# OTWAY WATER BOOK

## 42 B

Remediation of the Big Swamp Wetlands,  
Yeodene,

**“A Fresh Start.”**

## Big Swamp – What is not known

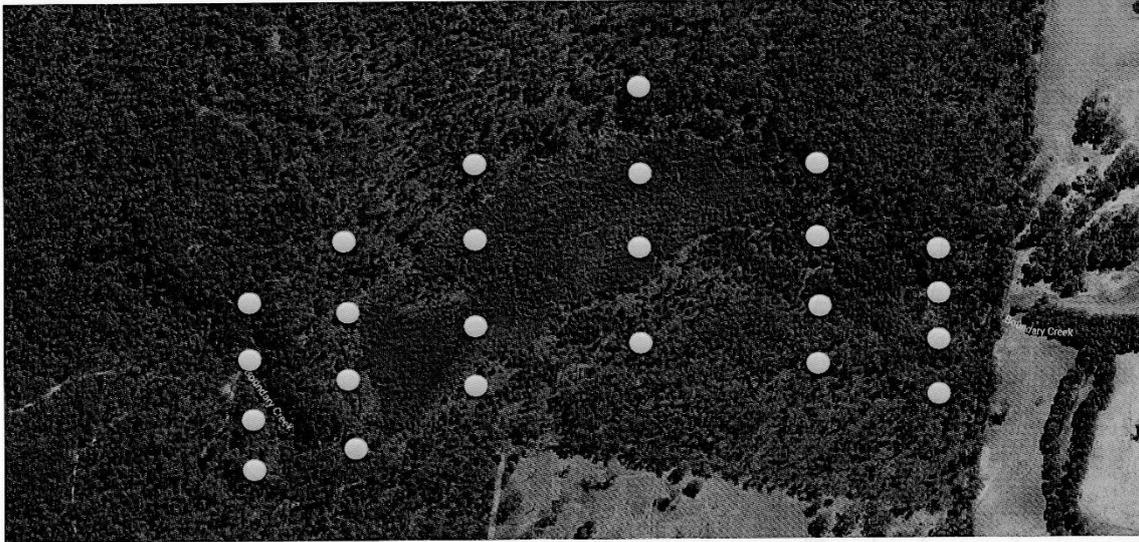
- The thickness, area, hydrology and age of the peat
- The surface topography and alternative drainage channels of the Boundary Creek through the swamp
- The elevation and topography of the peat
- Whether there is one big swamp or several smaller swamps?
- The <sup>ad volume</sup> area of fire affected peat
- The sub-crop of LT aquifer and interconnection with surface water and water in the peat
- The sub-crop of the LT aquitard beneath the peat

## Minimum Investigation program required before remedial Engineering works commence

- Survey the area of Big Swamp with contour interval 0.25 m
- Drill at least 24 holes (core or piston core), geologically log top and base of peat, LT Aquifer and Aquitard
- Establish at least 12 Piezometers in LT Aquifer and peat, sample chemistry, pH
- Record water levels, salinity and pH through peat
- Generate Geological structure contour maps of top and base of peat
- Construct Isopach map of peat and calculate volume of peat and volume of acid sulphate water contained

### **Drainage lines impacting on the Boundary Creek Catchment.**

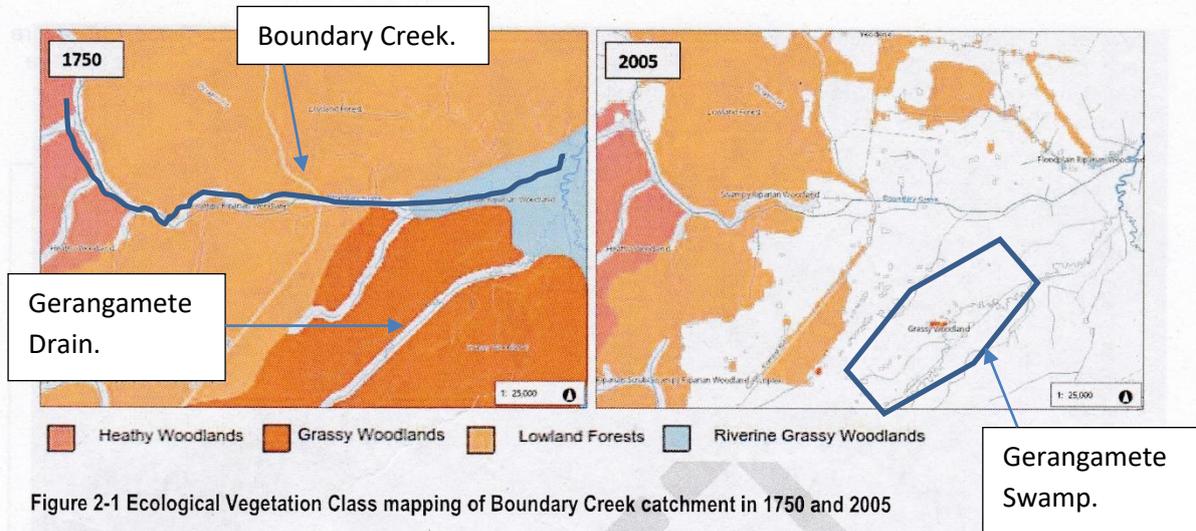
Regarding Jacobs statement, page 18, in the 9 November 2017 Yeodene Swamp Study and presentation by Prof. Webb.

***“The Boundary Creek catchment has undergone significant modification over the last century. In 1886 the Gerangamete drain was completed, followed by a series of adjacent drains in 1888 (Jennings, 2008). These drains claimed low lying land for agricultural production, and resulted in the removal of large sections of low land forest and grassy woodland, as evidenced by Ecological Vegetation Class mapping (Figure 2-1). The drainage of these areas is likely to have lowered the groundwater level near the drain and increased runoff, while reduced forest coverage may have increased groundwater recharge in these areas.”***

There are numerous mistakes and assumptions in this particular statement that require some comment.

1. Figure 2-1 found in the Jacobs report (copied below) contains a map dating back to 1750. This map is based on a massive amount of speculation and guesswork. The map also predates Captain James Cook’s exploration of the east coast of Australia by 20 years and the arrival of the First fleet by 38 years.
2. The Boundary Creek Catchment does not form part of the Gerangamete Swamp.
3. The Gerangamete Drain does not drain the Boundary Creek Catchment.
